Proposal for a supplement to the 12 series of amendments to UN Regulation No. 13 (Heavy vehicle braking)

Submitted by the expert from the European Association of Automotive Suppliers - CLEPA

The text reproduced below was prepared by the expert from the European Association of Automotive Suppliers (CLEPA) to include in UN Regulation No. 13 requirements for the type approval of Electro-Mechanical Braking (EMB) systems as state-of-the-art braking systems. This document supersedes the working document ECE/TRANS/WP.29/GRVA/2021/24 and the informal document and GRVA-14-12.

(ae) Paragraph 5.2.1.35.5.

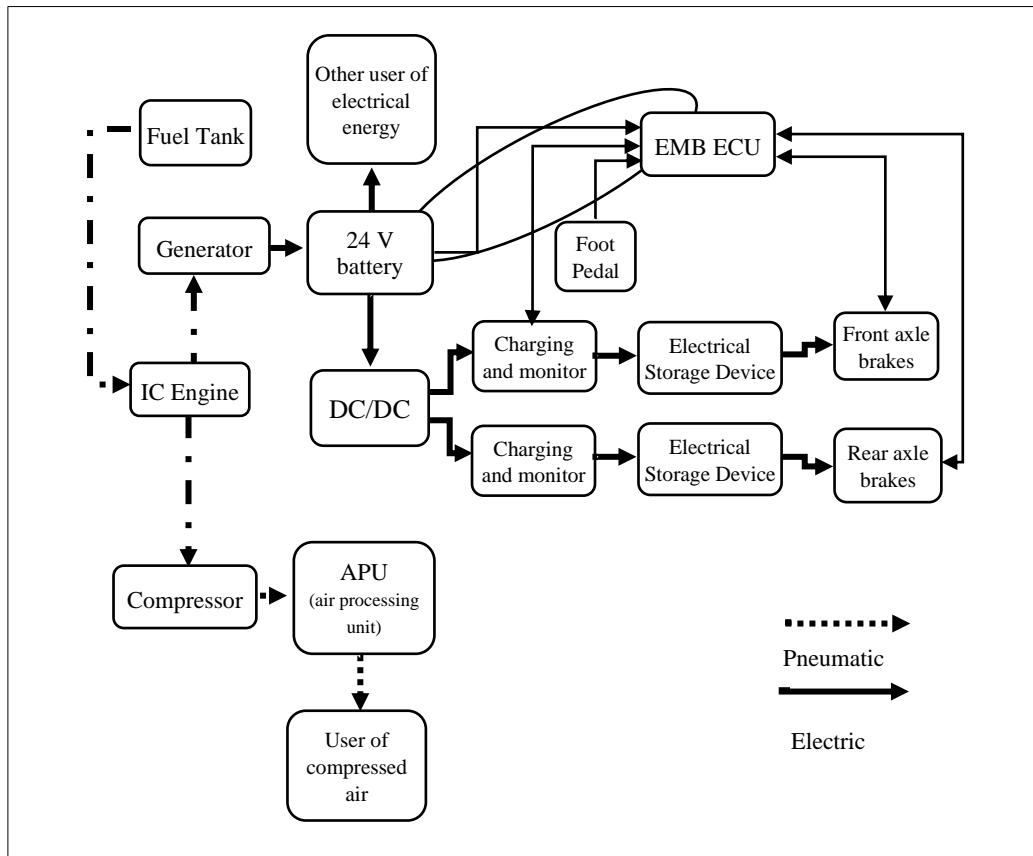
47. This requirement is similar to that in paragraph 5.2.1.27.5. but adapted to electro-mechanical braking systems. Paragraph 5.2.1.35.5. addresses a configuration of an electro-mechanical braking system where an electrical energy storage device (e.g. battery) only supplies electrical energy to the control transmission (but not also to the electrical energy transmission); as an exemplary simplified braking system see figure below.

48. The added test condition of "**With the control transmission in operation, the braking control shall be kept released for 20 minutes before performing 20 full stroke application ...**" takes into account of an EMB control system where the duration of the actuation time of the braking control is the most relevant test condition and not the number of brake actuations. In such braking systems electric energy is consumed during application and during the release of the braking control.

49. Since paragraph 5.2.1.35.5. defines only a test procedure for the required energy reserve of the control and not the energy transmission, it is permissible to switch off the electrical energy transmission during the test procedure in order to avoid the activation of the red warning signal due to the excessive consumption of electrical energy due to the 20 brake applications of the electrical energy transmission.

(af) Paragraph 5.2.1.35.6.

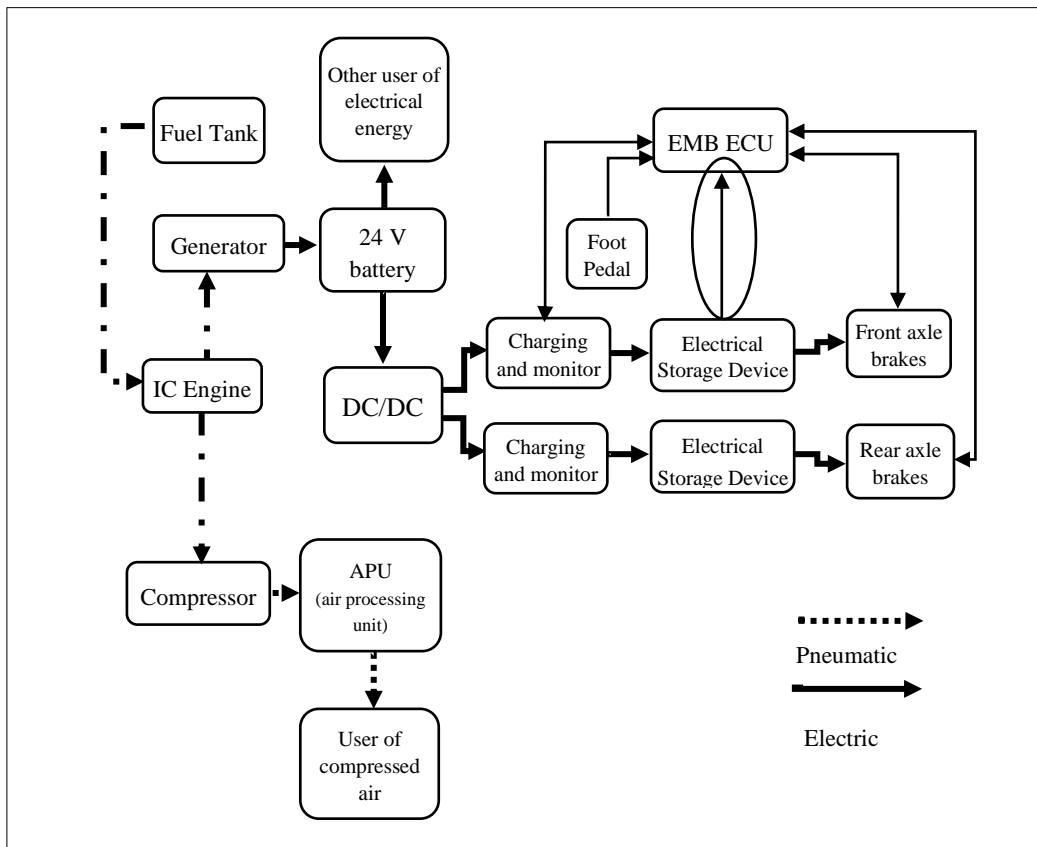
50. In contrast to paragraph 5.2.1.35.5., this requirement addresses a configuration of an electro-mechanical braking system where energy storage devices are providing electrical energy for the electrical control and electrical energy transmission; as an exemplary simplified braking system see figure below.
